DART AEROSPACE LTD	Work Order:	94350
Description: Crosstube Assembly (205/212/412 High Fwd)	Part Number:	D212-664-141
Inspection Dwg: D212-664-141 Rev: D		Page 1 of 2

DRAWING NO. REV. D
D212-664-141 SHEET 1 OF 4
TITLE SCALE
XTUBE ASSY (205/212/412 HI FWD) NTS

DRAWING NO. D212-664-141	TITLE XTUBE ASSY (205/212/412 HI FWD)	REV. D	DART AEROSPACE LTD ENGINEERING ORDER		D.E.O. NO. D212-664-141-D-1	SHEET NO. SHEET 1 OF 2	SCALE NTS
DRAWN	CHECKED	MFG. APPR.	APPROVED	DE APPR.			
DATE 11.04.07	DATE 11.04.11	DATE 11.04.12	DATE 11/04/12	DATE 11.04.12

ADD AN INSPECTION WINDOW TO UNDERSIDE OF CROSSTUBE.

D212-664-141/-141B
ASSEMBLY DETAIL

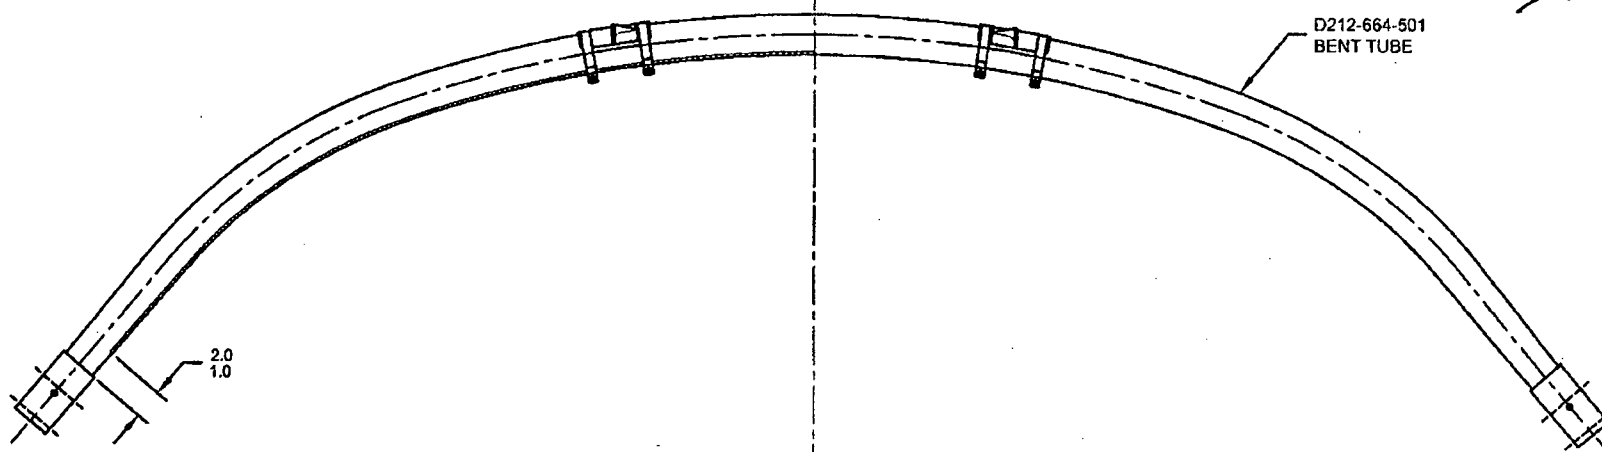
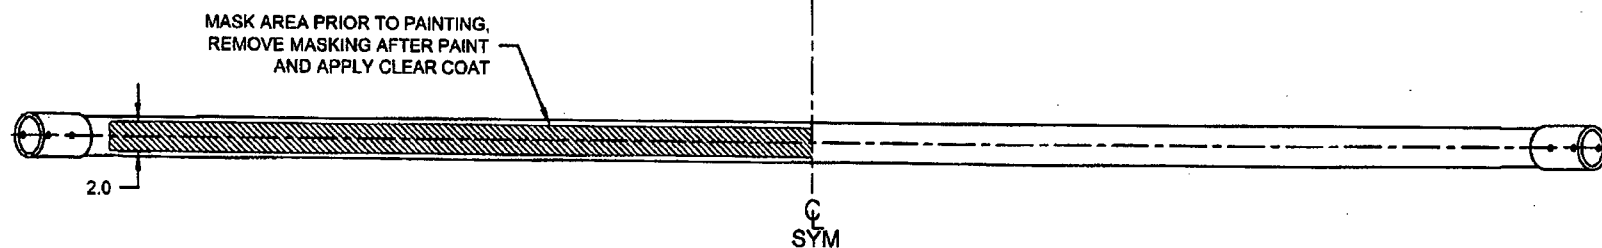
NOTES 2 OF SHEET 1 IS AMENDED AS FOLLOWS:

- 2) FINISH: CHEMICAL CONVERSION COAT PER DART QSI 005 4.1
PRIME INSIDE AND OUTSIDE PER DART QSI 005 4.2
PAINT OUTSIDE PER DART QSI 005 4.2

- 2) FINISH: CHEMICAL CONVERSION COAT PER DART QSI 005 4.1
PRIME INSIDE AND OUTSIDE PER DART QSI 005 4.2
MASK UNDERSIDE OF CROSSTUBE AS SHOWN (HATCHED AREA) AND
PAINT OUTSIDE PER DART QSI 005 4.2
REMOVE MASKING AND APPLY CLEAR COAT
